SUBJECT: Transmittal of Westinghouse Responses to US NRC Requests for Additional Information on the AP1000 Application for Design Certification

AP1000 DESIGN CERTIFICATION REVIEW

Response to Request For Additional Information

Figure 7-3 Core Shroud Beam Modes With and Without Core

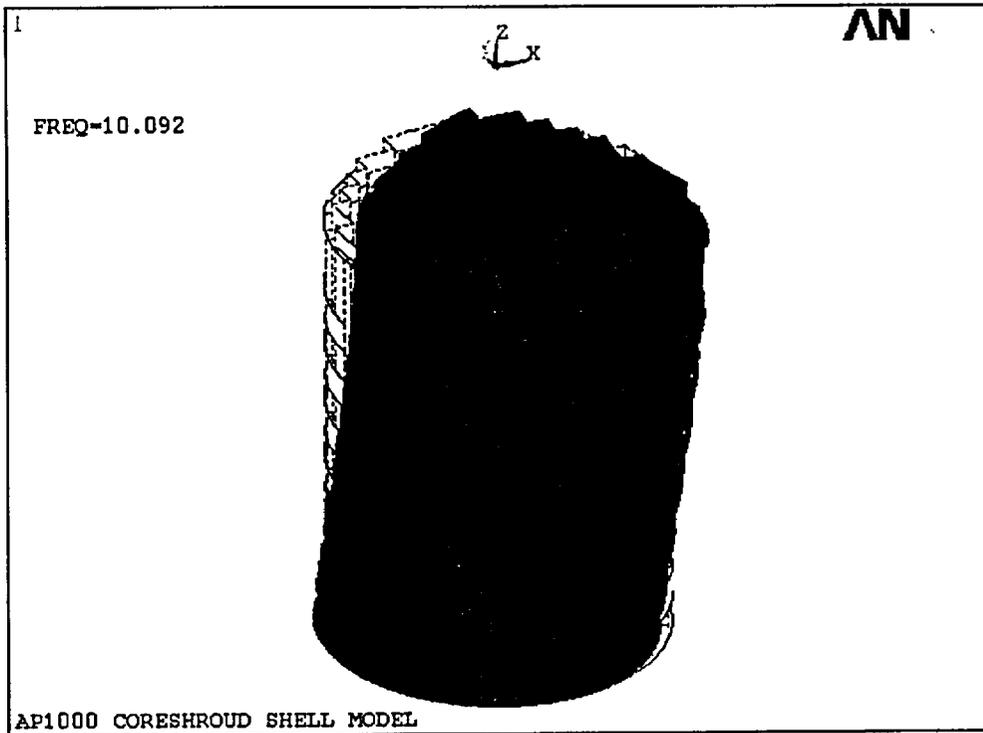
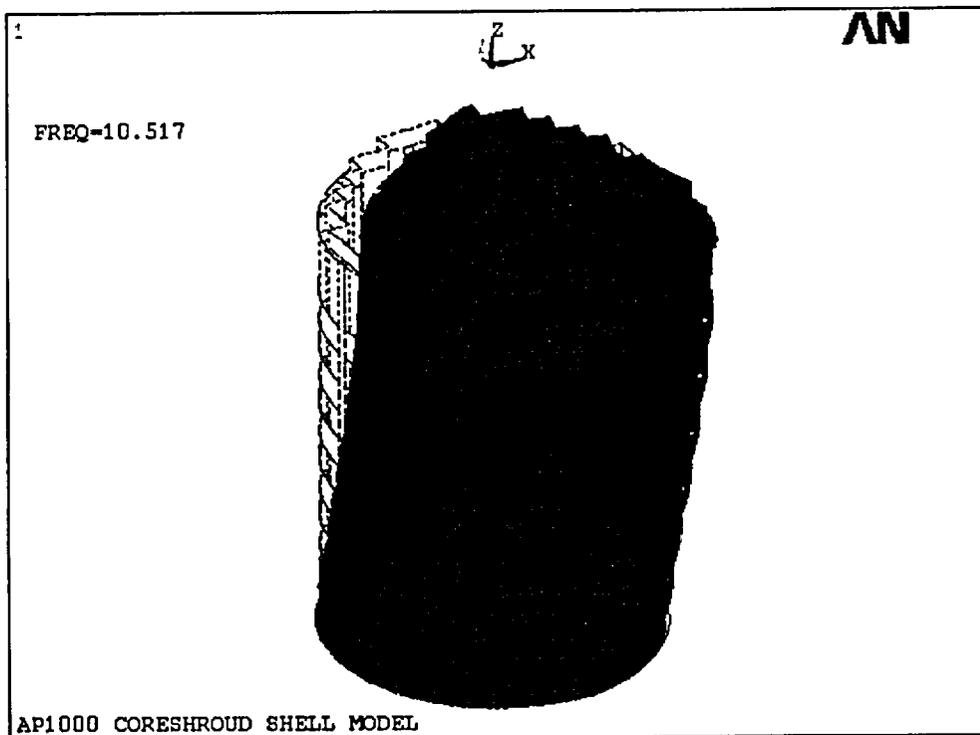
9. Pg. 7-11, Fig. 7-3. These figures are graphically confusing; what is intended? what is the frame of reference, or coordinate system?
10. (Editorial) Superscripts, including the lower case letters 'a', 'b', and 'c', are used throughout the text and tables without accompanying footnotes explaining their meaning. Examples include Pg. 1-1, last paragraph, Pgs. 3-4, 4-2, and 6-2, Tables 4-2 through 4-7, Tables 5-3 through 5-6, etc. Please clarify the meaning of these superscripts.

9. Page 7-11: The purpose of Figure 7-3 is to show that the core shroud beam modes are very similar both with and without the core included in the model. Figure 7-3 will be revised to show a different angle of the core shroud model to help clarify the mode shape. An indication of the coordinate system will also be added to the figure.

Figure 440.154-1 Downcomer Pressure Comparison.
Hot Leg Entrainment Onset Study

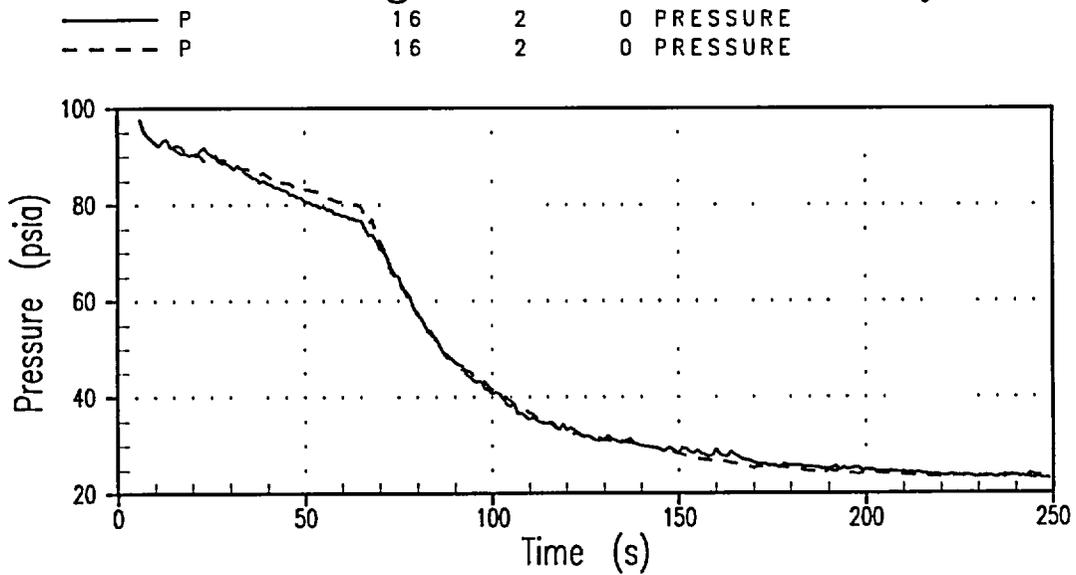
- (c) Provide justification that the variation of the Top Offtake Orientation model in Section A.4.4 is sufficient to account for inaccuracies in the model when compared to experimental data. Figure 2 shows the variations considered in the sensitivity study. When data from ATLATS tests are compared to the correlation and its variations in the sensitivity study, it can be seen that the branch line quality is grossly over-estimated for the two cases in which the offtake quality was reduced compared to the Reference. For example, at Froude numbers less than one the data suggests very low branch line quality while the correlation and its variations predict very high quality ($x > 0.75$).

- b) The attached Figure 440.154-1 compares the downcomer pressure during the ADS-4 IRWST initiation phase for the increased entrainment onset correlation coefficient (solid line) and the decreased entrainment onset correlation coefficient (dashed line). The time scale is the same as in Appendix A.4 of WCAP-15833. Prior to 65 seconds, only one ADS-4 flow path is open. At 65 seconds, the pressure in the small coefficient case is about 3 psi higher than in the large coefficient case. This result is consistent with Figure 154-2 in that the higher branch line quality associated with the large coefficient might be expected to produce a more effective depressurization of the AP1000 than that observed in the small coefficient case, with its lower quality. However, once the additional two ADS-4 flow paths become available at 65 seconds, the pressures converge. This indicates that the AP1000 design has adequate depressurization capability that, even assuming a single failure, the pressure result during ADS-4 operation is not sensitive to the variation in the entrainment onset correlation coefficient.

FIGURE 440.160-4: TOTAL GAP STEAM FLOW RATE

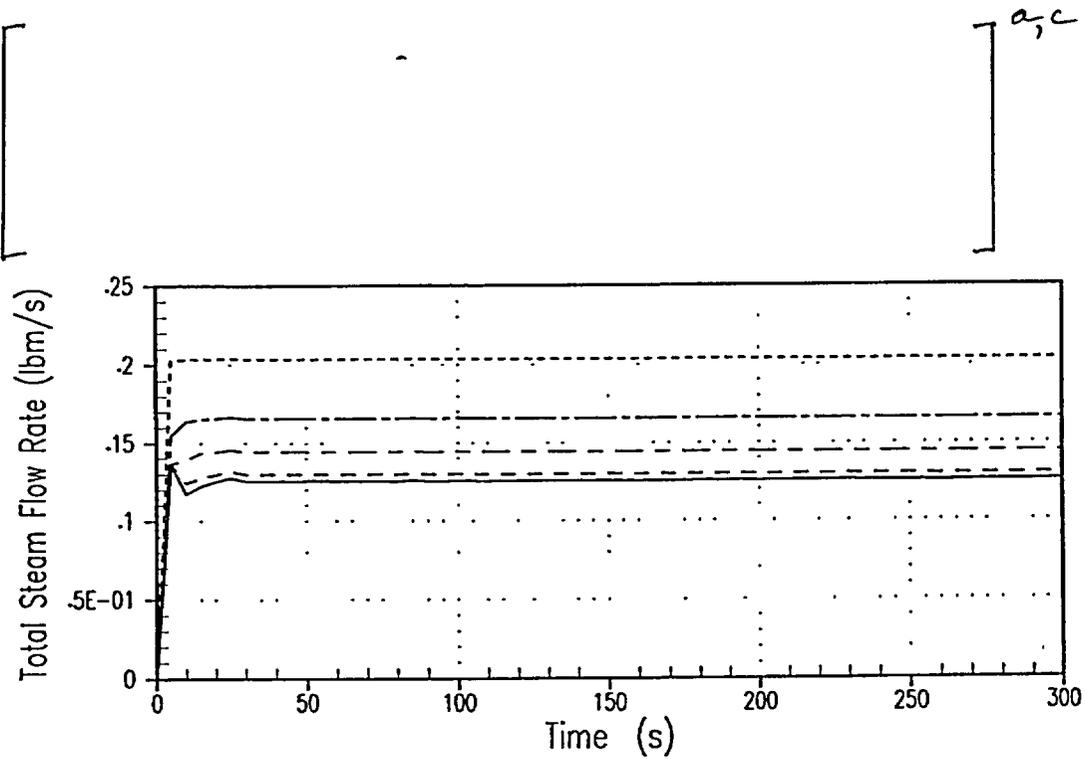
Please provide Figures 2-9, 2-11, and 2-13 that include a key, or clearly indicate what the individual curves represents. In addition, explain why there are periodic oscillations in the steam flow rate (see dashed curves in Figure 2-13) although the pressure differentials along the channel remain relatively constant (see Figure 2-11).

results are very stable at all gap locations, as shown in the attached Figure 440.160-4. The variation in the []^{a,c} the

Figure 440.171-1: Upper Plenum Level, DEDVI Break Case

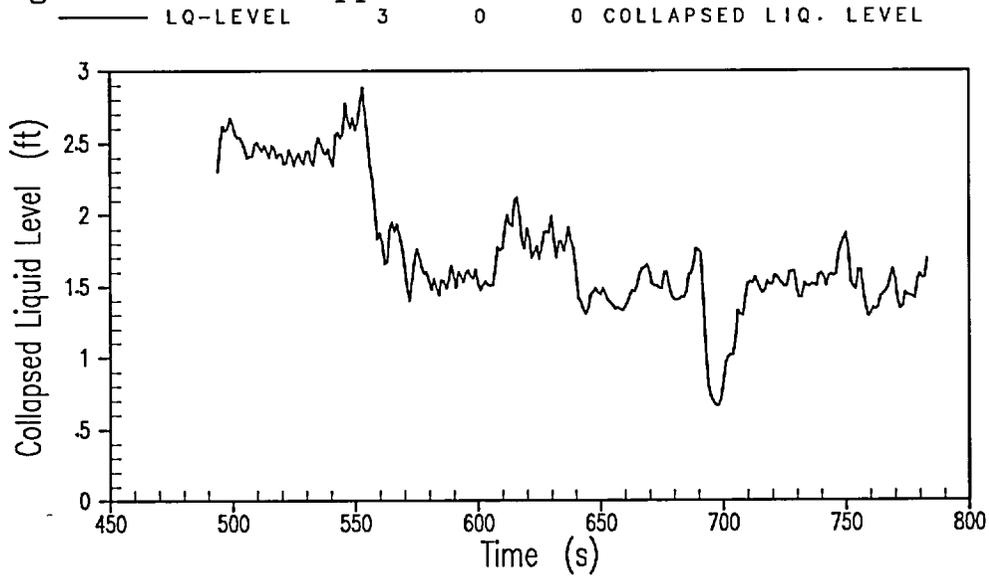
Figures A.3-4 and A.3-5 show a prediction of WCOBRA/TRAC upper plenum entrainment versus time for conditions simulating a DVI line break. Please provide the WCOBRA/TRAC collapsed liquid level for this simulation.

The collapsed liquid level in the upper plenum from the WCOBRA/TRAC DEDVI line break simulation presented in Appendix A.3 is shown in Figure 440.171-1. The level shown is relative to the top elevation of the active fuel length.

Figure RAI 720.013-14
DVI-B Mixture Flow Rate (Case F)

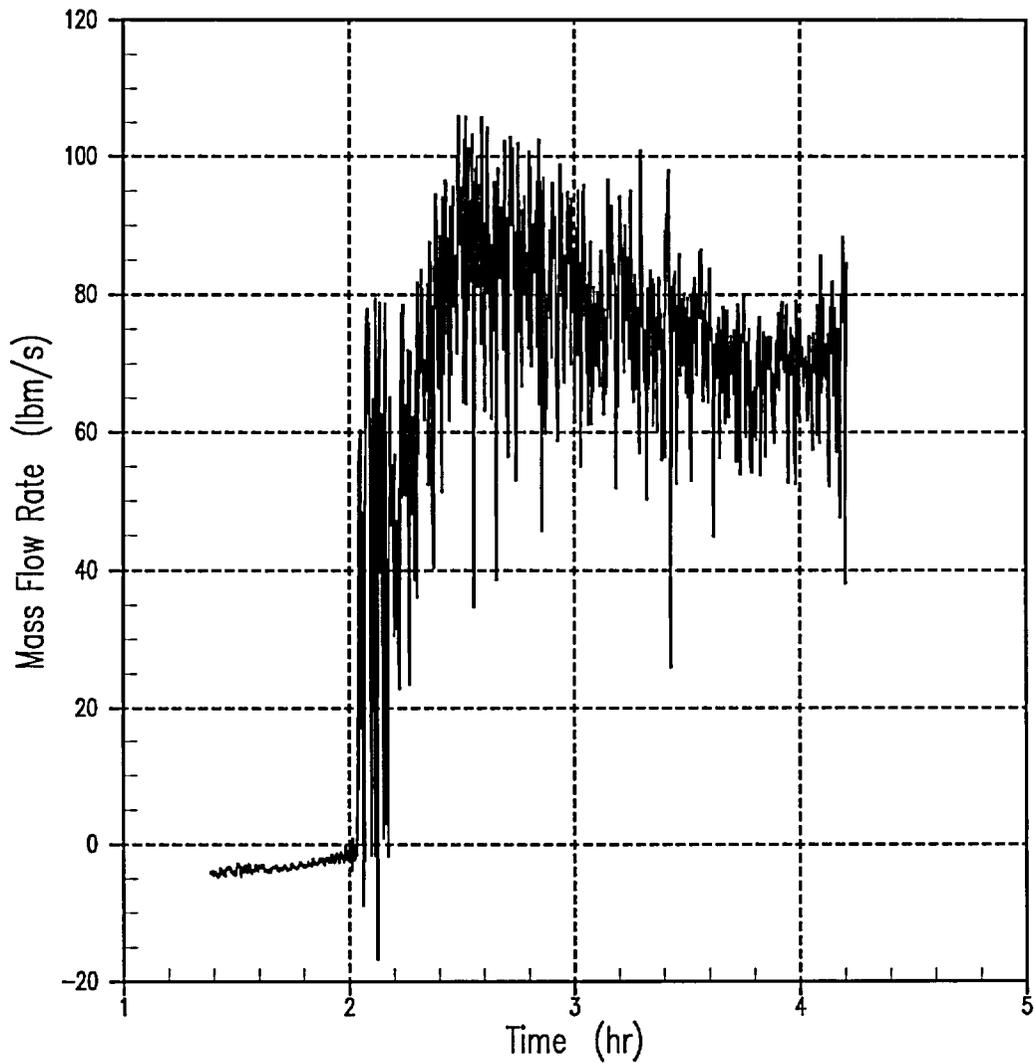
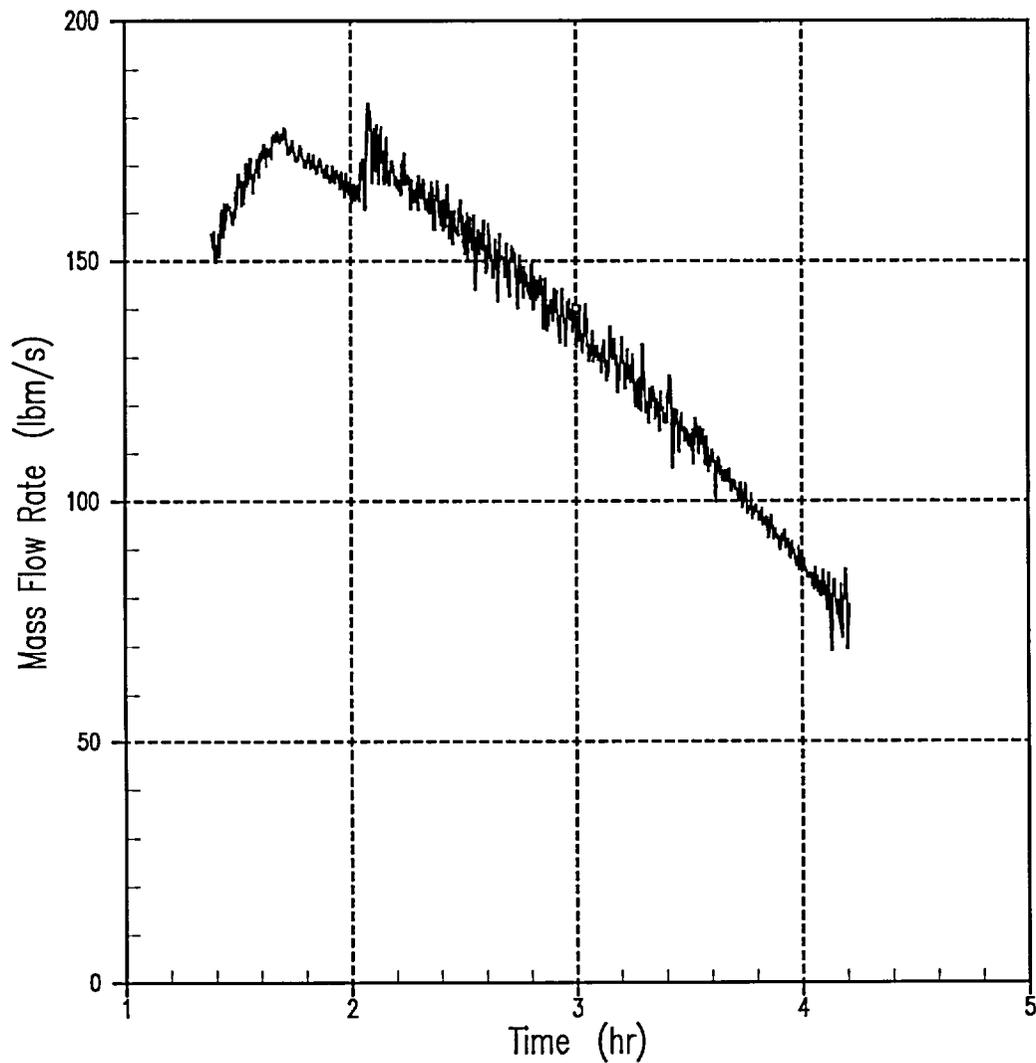
- B. Section 1 states that it is conservatively assumed that the DEDVI line break occurs in the PXS-B room, since the size of this room is bigger than PXS-A. In Section 4.1, 3rd paragraph, it is stated that "initially, the only injection comes from the IRWST into the reactor vessel through the intact DVI injection line (Fig. 720.013-14). Since the level in the PXS-B room is below the DVI injection nozzle elevation, only steam from downcomer is vented out through the break (Fig. RAI 720.023-13[TYPO])." However, Figure 720.013-14 shows DVI-B mixture flow rate, and Figure 720-013-13 shows DVI-A mixture flow rate. There appears to be discrepancies on the break location. Clarify whether the break is in DVI-A or DVI-B.

- C. Same question for Section 4.2, Figures 720.013-14 and -13.
- D. WCOBRA/TRAC boundary conditions including the interaction between the AP1000 primary system, passive safety systems, containment, and containment systems are stated to be calculated with MAAP. The NRC staff has not reviewed and approved the MAAP code for this purpose. (See open issues involving RAI 720.021 below). Furthermore in the response to RAI 440.009 (dated Sept 12, 2001) Westinghouse indicated that MAAP would not be used with WCOBRA/TRAC for long-term cooling analysis. This issue will remain open until Westinghouse provides long term uncertainty analyses using approved methodology.

Current	Revised
A5.3-13	Case F – DVI-A Mixture Flow Rate	Case F – DVI-B Mixture Flow Rate
A5.3-14	Case F – DVI-B Mixture Flow Rate	Case F – DVI-A Mixture Flow Rate
A5.3-27	Case G – DVI-A Mixture Flow Rate	Case G – DVI-B Mixture Flow Rate
A5.3-28	Case G – DVI-B Mixture Flow Rate	Case G – DVI-A Mixture Flow Rate

Initially, the only injection comes from the IRWST into the reactor vessel through the intact DVI injection line (Figure RAI 720.013-14). Since at the beginning of the analysis, the level in the PXS-B room is below the DVI injection nozzle elevation, only steam from downcomer is vented out through the break (Figure RAI 720.023-13). Water starts to flow back into the downcomer through the broken DVI line about 2 hours into the transient. This is the time when the level in the PXS-B room becomes high enough to provide sufficient driving head. At the onset of this event the additional amount of water supplied into the downcomer through the DVI break supplement's the IRWST injection. This leads to enhanced core cooling and momentarily, faster depressurization occurs at about 2.05 hours into the transient (see Figure RAI 720.013-11). Consequently, the IRWST injection is increased even further and as a result, the levels in the downcomer (Figures RAI 720.013-1), the reactor core (Figures RAI 720.013-2) and the upper plenum (Figures RAI 720.013-8) are also increased. The effect of this injection flow increase can also be seen on Figure RAI 720.013-4, which shows a sharp void fraction decrease in the upper half of the fuel region.
